SAFETY EVALUATION REPORT  
CALVERT CLIFFS NUCLEAR POWER PLANT  
ADDITIONAL SHORT TERM RECOMMENDATION 2  
FOR AUXILIARY FEEDWATER SYSTEMS

SAFETY EVALUATION BY THE OFFICE OF NUCLEAR REACTOR REGULATION

SUPPORTING AMENDMENT NOS. 67 AND 49 TO

CALVERT CLIFFS NUCLEAR POWER PLANT, UNIT NOS. 1 AND 2

Figure 3.7-1  
Steam Generator Pressure vs. Auxiliary Feedwater Flow

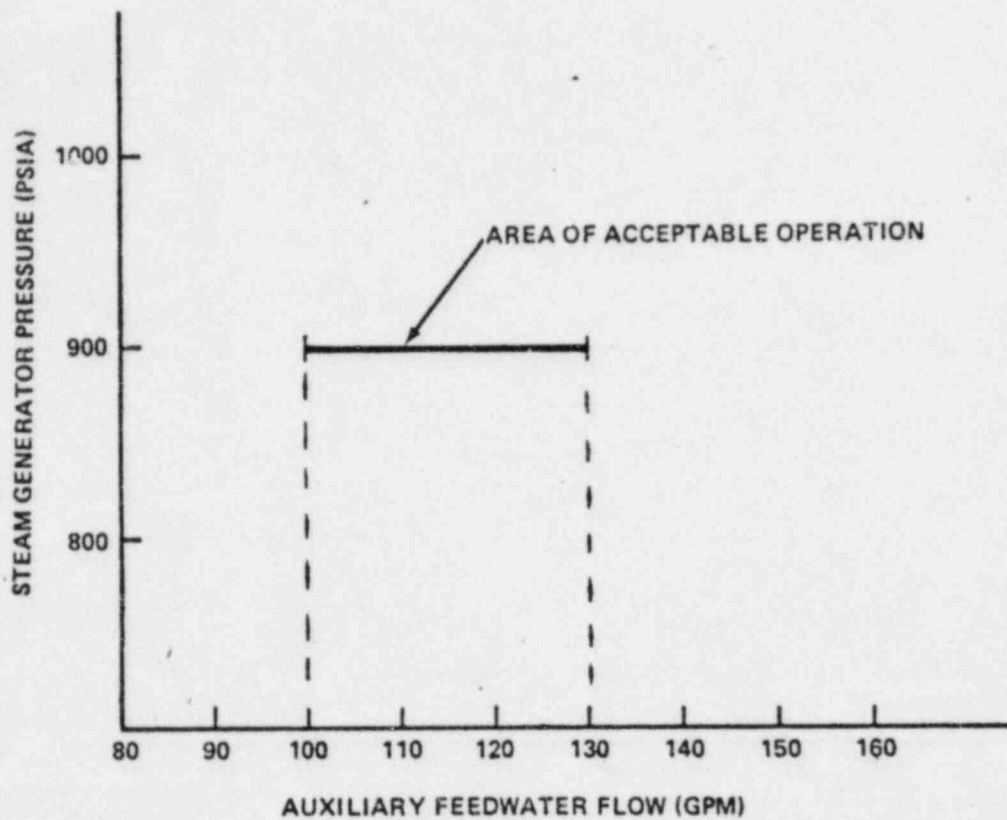
3.7.1.2 At least two steam turbine driven steam generator auxiliary feedwater pumps and associated flow paths shall be OPERABLE and capable of automatically initiating flow, within the area of acceptable operation of Figure 3.7-1, to each steam generator.

As indicated in the December 21, 1981 BG&E application, an automatic AFW flow of between 88 gpm (plus 12 gpm for instrument error) and 142 gpm (minus 12 gpm for instrument error) provides an acceptable range of initial AFW flow to each steam generator at 900 psia. The lower limit of acceptable, automatic, AFW operation, 88 gpm, allows 20 minutes for the reactor operator to manually increase AFW flow to the desired value to maintain an adequate primary system heat sink, should AFW operation be required. The upper limit of acceptable, automatic, AFW operation, 142 gpm, allows 20 minutes for the reactor operator to terminate AFW operation should main feedwater be available; failure to terminate AFW operation, in this case, could lead to primary system overcooling and subsequent safety injection actuation. Based upon the above, it is appropriate to set the AFW throttle valves to deliver between 100 and 130 gpm per steam generator, at 900 psia and this requirement should be incorporated in the TS.

At the present time, TS 3.7.1.2 requires the operability of the AFW system and associated flow paths. The BG&E application proposed that the automatic flow initiation feature, with throttle valves set between 100 and 130 gpm at 900 psia, also be required to be operable. Operability of this feature in Mode 3 (hot standby) is not proposed since under non-power conditions, the AFW need not be automatically initiated to maintain an adequate primary system heat sink. The Bases for TS 3.7.1.2 have been proposed for modification to reflect the rationale for selection of AFW throttle valve settings.

Based upon our evaluation, we find that the proposed changes to the TS, and associated Bases, are acceptable. The TS, as amended, assure that the AFW throttle valves will be properly set such that sufficient time is permitted for the reactor operator to terminate AFW operation, or increase AFW flow, as required. In addition, the augmented surveillance requirements provide sufficient confidence that the AFW throttle valves will be properly adjusted and readjusted should their setting be altered. Accordingly, we conclude that the consequences of transients and accidents for which AFW operation is required, and for those transients and accidents for which AFW operation is not desirable, have not increased.

Figure 2.7-1  
Steam Generator Pressure vs. Auxiliary Feedwater Flow

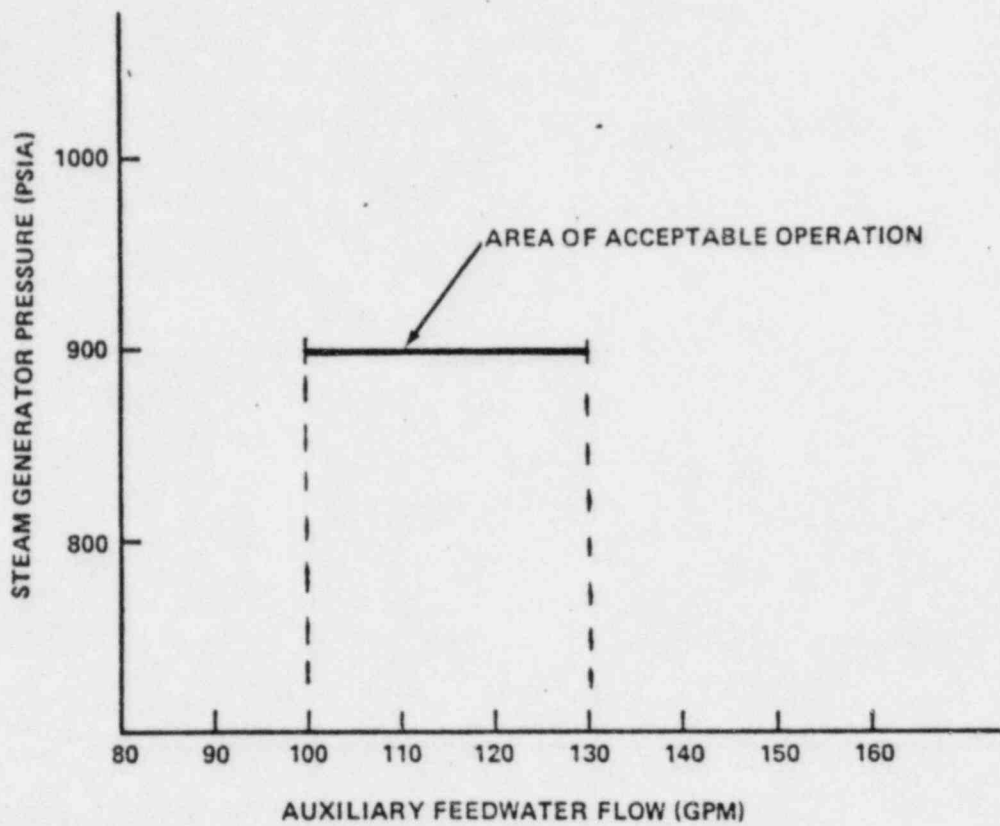
3. Verifying, upon automatic initiation of auxiliary feedwater, a flow within the acceptable operating limits of Figure 3.7-1, Steam Generator Pressure Versus Auxiliary Feedwater Flow.
- \*d. Upon repositioning of 1/2-CV-4511 and/or 1/2-CV-4512 the valve shall be realigned to provide flow consistent with Figure 3.7-1.

In addition to the surveillance requirements of TS 4.7.1.2, BG&E has proposed two additional requirements. The 18 month AFW surveillance described in TS 4.7.1.2c would be augmented by adding proposed TS 4.7.1.2c.3 which requires verification of automatically initiated AFW flow to be between 100 and 130 gpm, per steam generator, at a steam pressure of 900 psia. In addition, TS 4.7.1.2d would be added to require verification of proper realignment of AFW throttle valve settings should these throttle valves be repositioned.

The requirements of TS 4.7.1.2d would not be applicable during MODE 3 since the automatic initiation features of the AFW is not required to be operable in MODE 3. It is our intent however, that the licensee realign the AFW throttle valves as soon as practicable following entry into MODE 2 (operation up to 5% power) if necessary.
